APPENDIX C1.8 – Consultation Record

Attachment #5 – Landfill Property Impacts

Comment #	Reference to Draft EA	Reviewer Comments & Rationale	Reviewer Proposed Action/Solution	Proponent's Response - DRAFT
1.	Executive Summary – General	The Executive Summary (and generally the Draft IEA Report) does not acknowledge the potential for landfill gas to be present in the transportation corridor in the vicinity of the 3 closed landfills, and by extension, has not considered this health and safety hazard in the evaluation of options (evaluation of preferred option) for the project.	<p>The project proponent should edit and reconcile the evaluation of options presented in the Draft IEA Report, including the Executive Summary, to acknowledge the potential for landfill gas to be present in the transportation corridor and the associated health and safety hazards, both during the construction period and after the road corridor has been placed into service.</p> <p>The evaluation of the Preferred Alternative Alignment may be impacted by the omission of the health and safety hazard associated with the potential for landfill gas to be present in the proposed transportation corridor. The impact of th

O2_NMRP_Teston 2024-12-16 NMRP
Rd_Memo_City Review Teston Rd Options.pdf

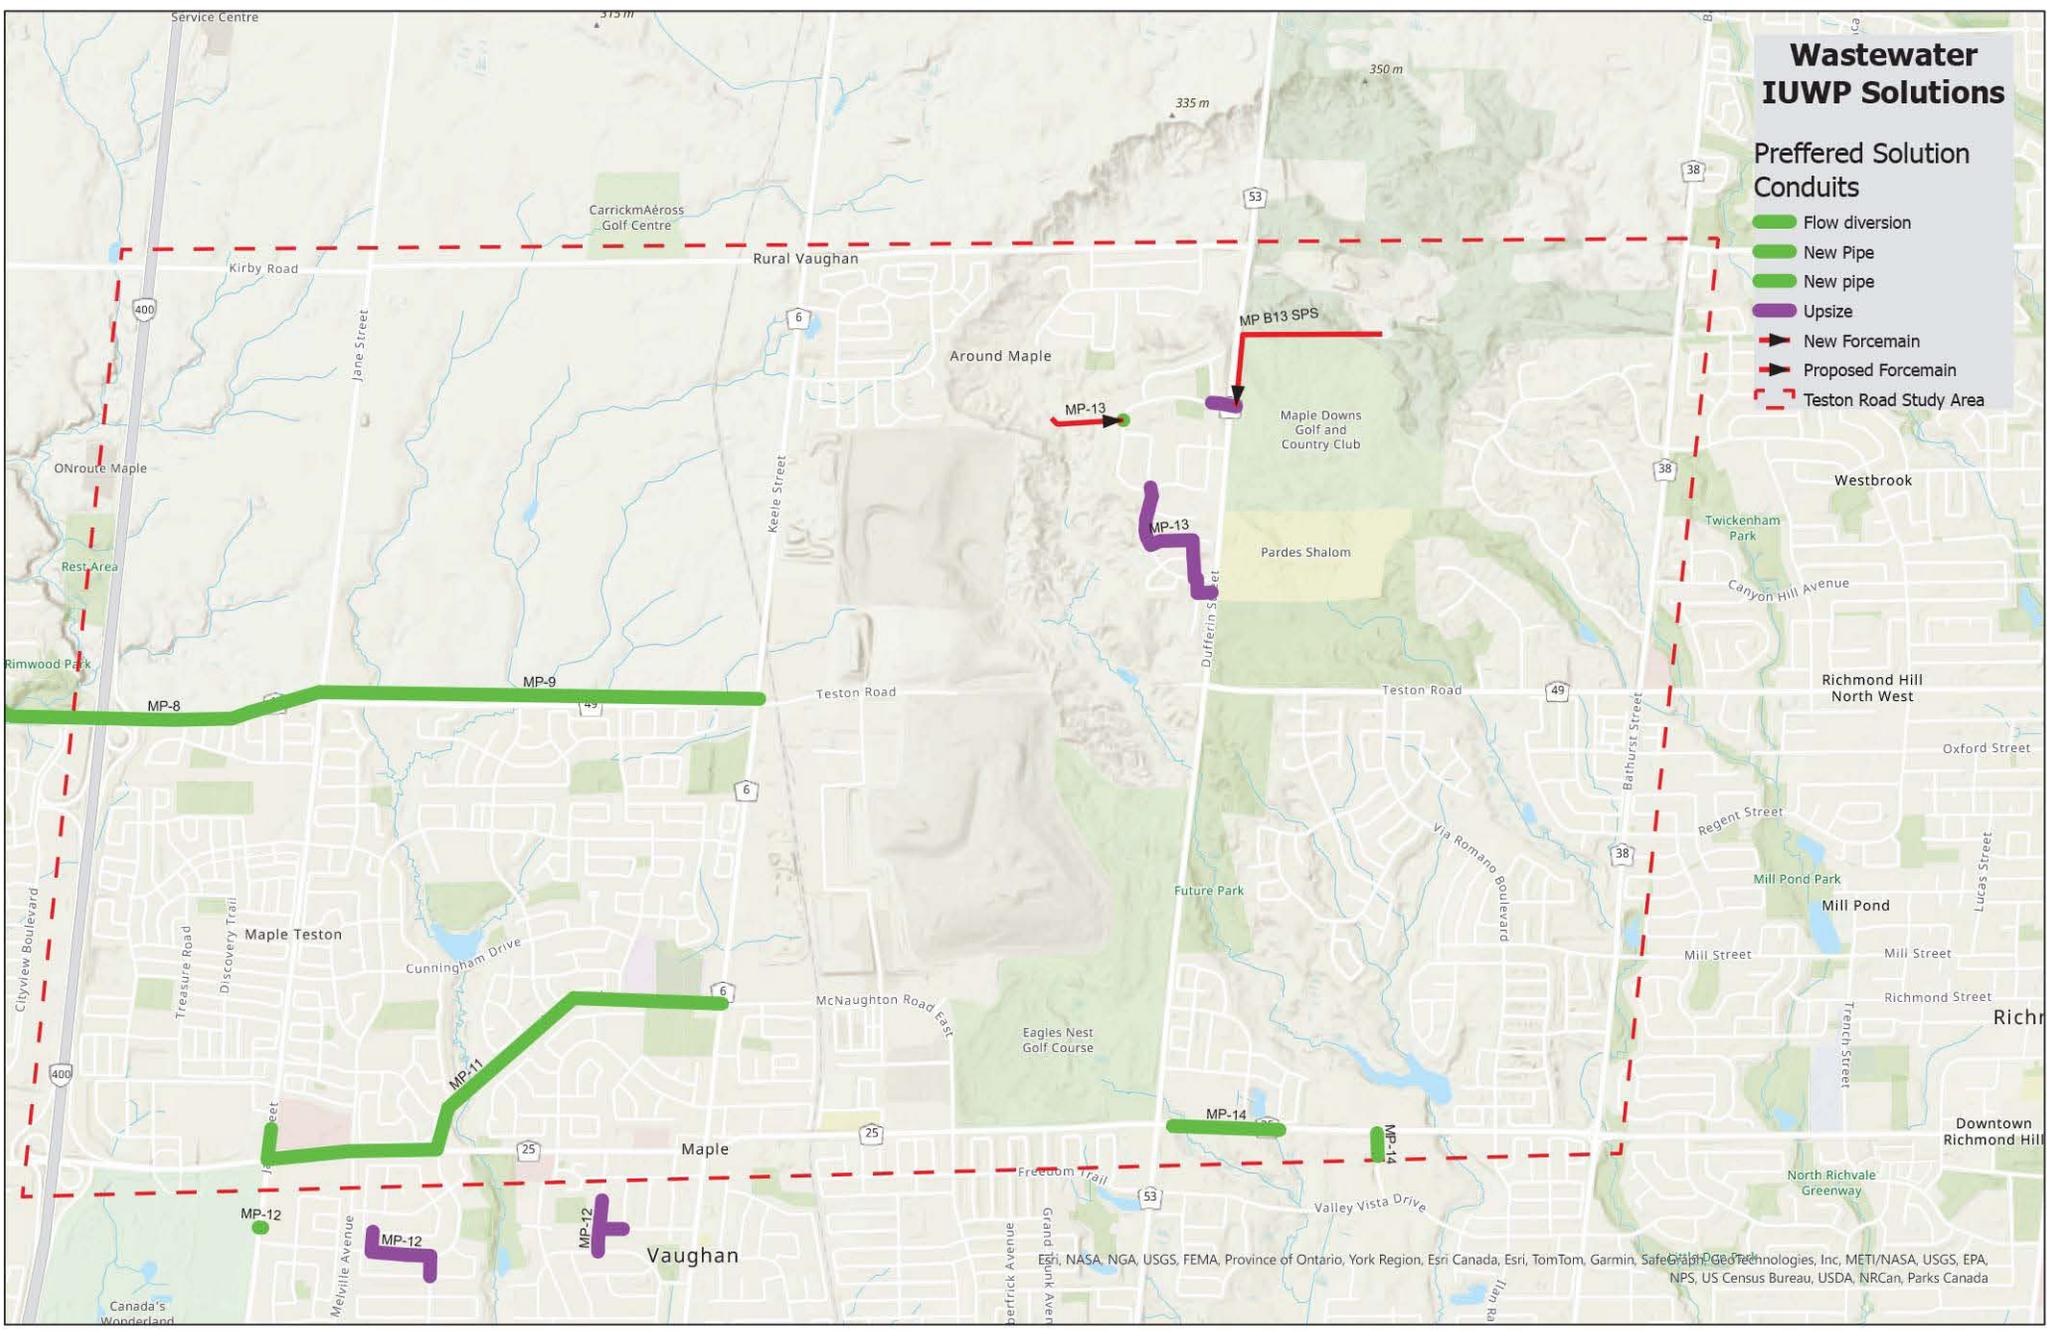
Detailed comments developed with the consultant (O2) have been attached below.

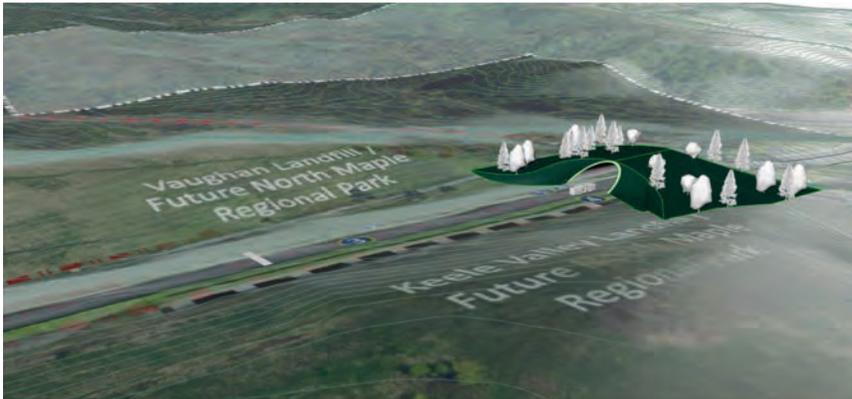
- Given that the interim conditions shown below will be in place for an extended period, it should be enhanced to create a more safe and enjoyable experience for pedestrians and cyclists.

- What is the rationale for a 4-lane road in year 49? See precedent of Central Park NY, where the 36m ROW of vehicular lanes are reduced to promote active transportation.

- Progress the design of the desired future build-out which includes the MUP or sidewalk and cycle track on the south side of Teston Rd.

Section 2: Rodinea Rd to Valley Crossing | BbMt` ` oObI

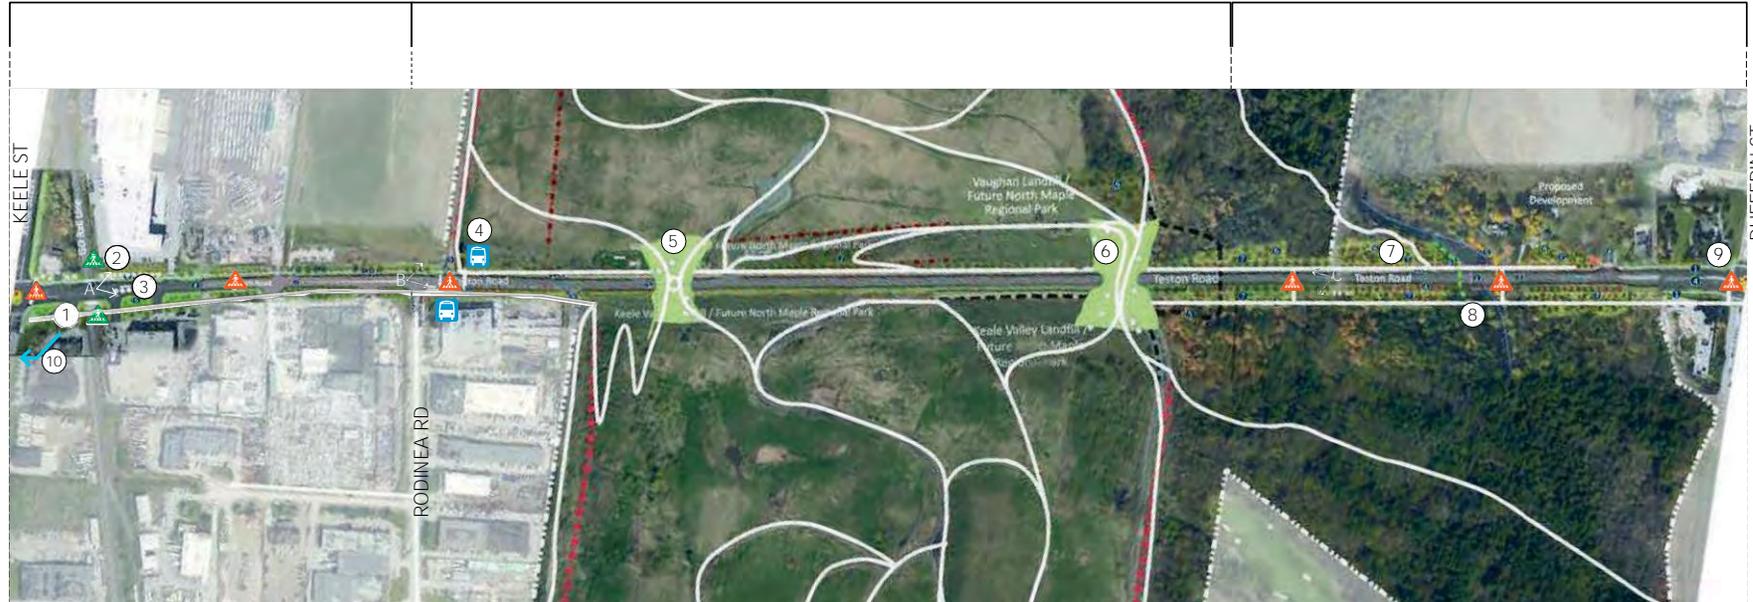
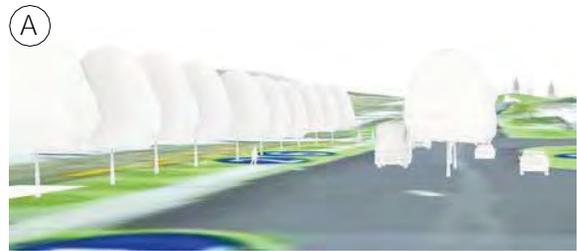
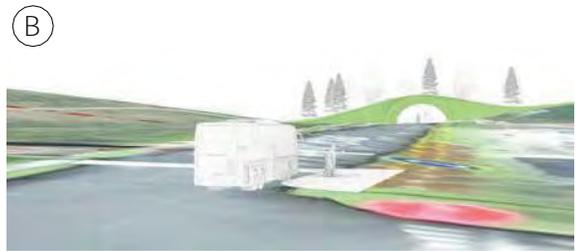
- ② York Region to progress design of the safe GO Rail Crossing for O2 to incorporate into the NMRPMP.
- ③ Consider a center median to enhance treed boulevard at park entry.

- ⑧ NMRPMP to incorporate York Region's design of bridge, wildlife passage and connect the lower trail to the Maple Nature Reserve trails to the east and to NMRP trails to the Headwaters district within the park.

- ⑨ East gateway into the park.
- ⑩ IEA proposes stormwater low towards retention area southwest of Teston Rd and Keele St via ditching culverts.

DESIGN MPB	TESTON ROAD (Y.R. 49) RECONSTRUCTION FROM KEELE STREET (Y.R.6) TO BATHURST STREET (Y.R.38)	DWG. NO.
DRAWN YG		CONT. NO.
CHECKED MPB	PRELIMINARY DESIGN-ULTIMATE 2+665 TO 2+972	SHEET NO. 7

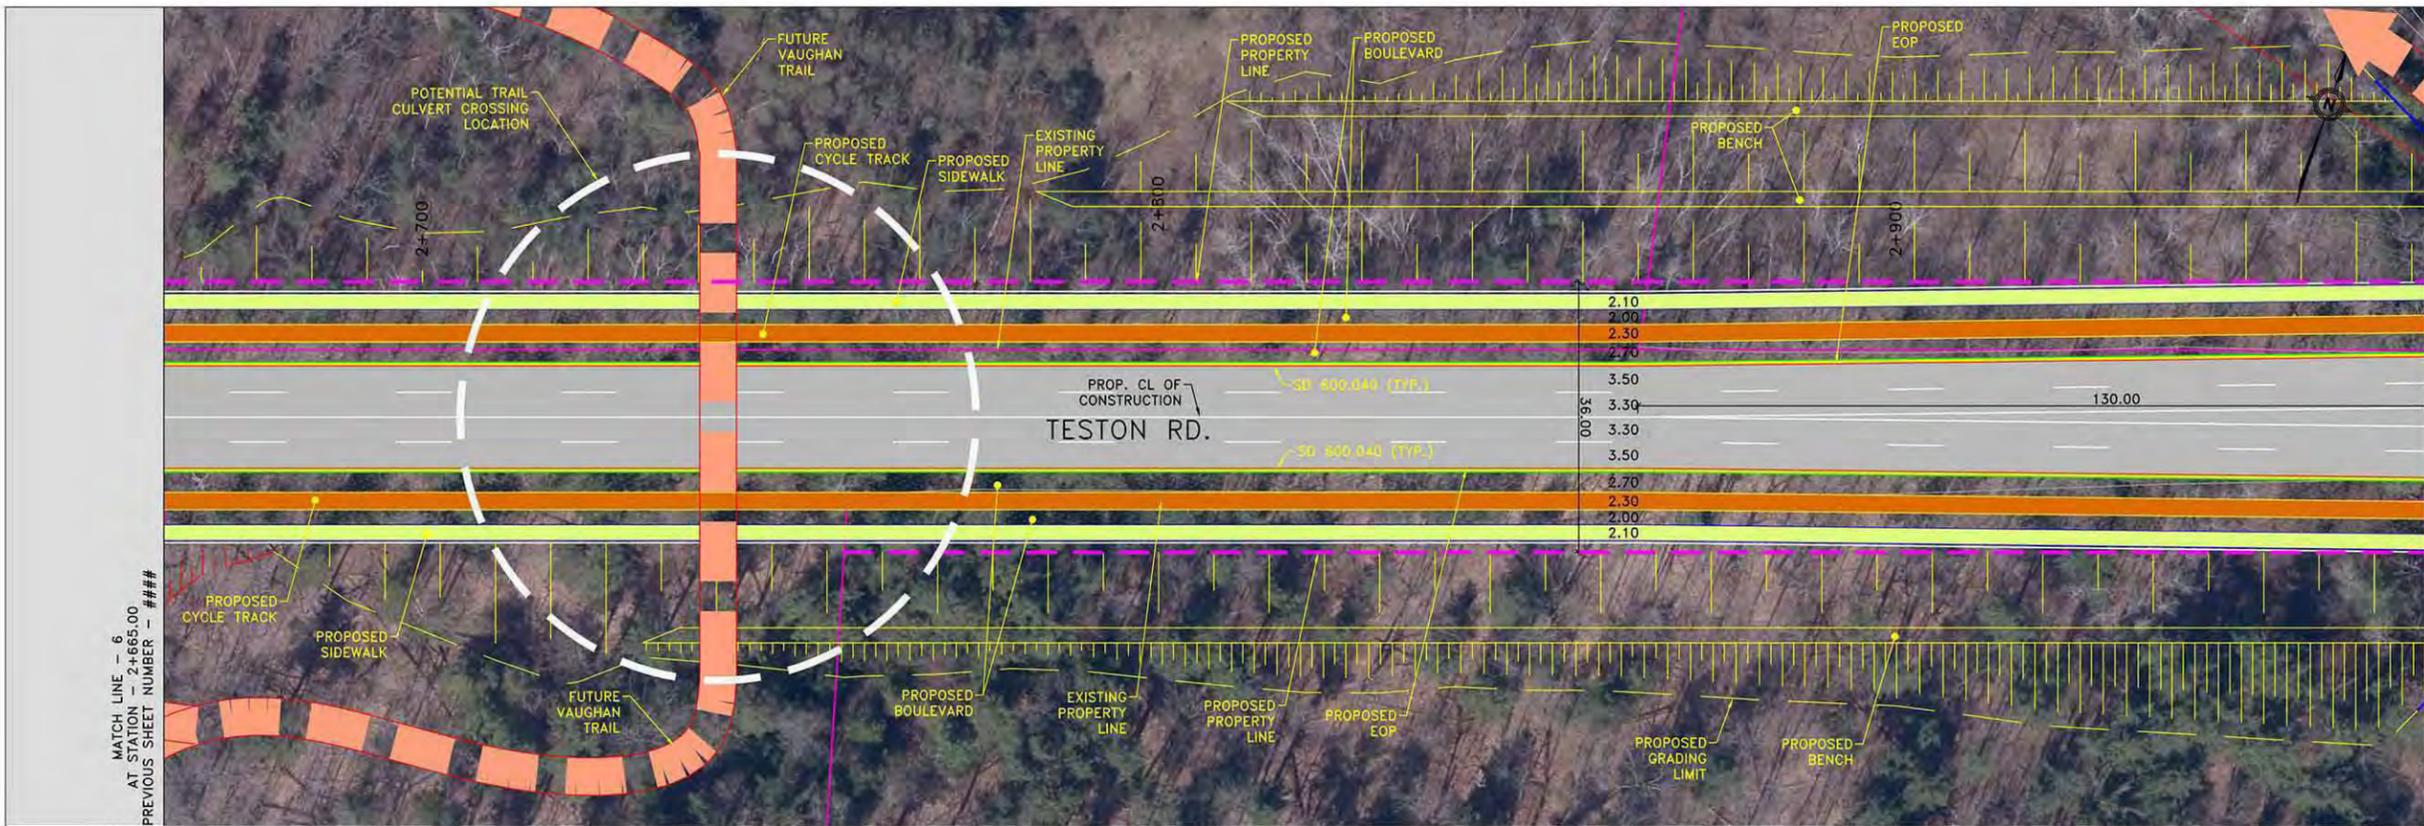
Proposed Property Acquisition
from City of Toronto
+/- Sta. 2+665 to Sta. 2+757 Approx.
Area = 637 m2

Proposed Grading Easement on City of Toronto
Property +/- Sta. 2+665 to Sta.
2+757 Approx. Area = 989 m2

<p><i>associated with the construction and excavation activities.”</i></p> <p>Comment: Insufficient information has been provided to the City of Toronto to assess the validity of this statement. Preliminary design drawings in plan view and cross section, showing legal property boundaries have not been provided in the EA report.</p> <p>The author should indicate how this meets Section 5.2.2. of the D-4 Guideline identified above with respect to the technical controls for groundwater compliance monitoring.</p>		<p>added to the EA Report to provide recommendations for assessing and mitigating specific and identified impacts to landfill infrastructure.</p> <p>Significant modifications have been made to Appendix L – Hydrogeology Report. Figures showing the groundwater and leachate-related infrastructure have been improved in the Hydrogeology Report and the impact assessment has been updated.</p> <p>Please also see response under Item 10 regarding the D-4 Guideline.</p> <p>Updated drawings in plan and cross section are attached for the KVL. See Letter Attachments #1 to #5.</p>
